Response to Second Review Comments

To City of Scottsdale Planning & Development Services 7447 E Indian School Road Scottsdale, AZ 85251	Project Mesrop & Mariam Megerdichian Residential Health Care Facility 8849 E Cholla St Scottsdale, AZ 85260 APN 217-26-949	
Attention Greg Bloemberg, Senior Planner	Case Number 25-ZN-2018 and 19-UP-2018	Date December 19, 2020

Building Elevation Design

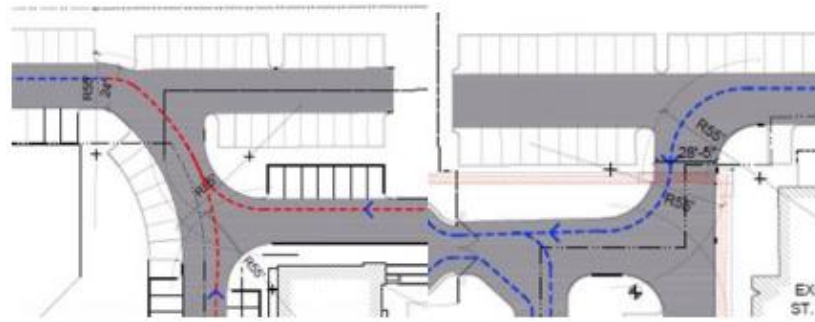
Comment 7 *Though shading on the building has generally been addressed with the 2nd submittal, there are still several windows on the west, south and east sides of the building that do not have any screening. Please revise the building elevations to provide solar shading of window surfaces on these three sides of the building. /*

The building elevations have been revised to best accommodate shading and screening as follows:

1. Previous windows at the first floor that were not directly beneath a projected balcony above are now recessed a total of 16 ½ inches from the primary façade plane of the building on all elevations. Two windows on the east elevation at the courtyard/basement level have also been recessed 16 ½ inches from the primary façade plane of the building.
2. A total of (12) twelve windows that received no shading or screening previously; (6) six each on the West and East elevations have been eliminated.
3. Canopies above third floor windows have been extended an additional two feet (from 3'-0" to 5'-0") when measured from the primary facade plane of the building.
(See Sheet A13 for more information)
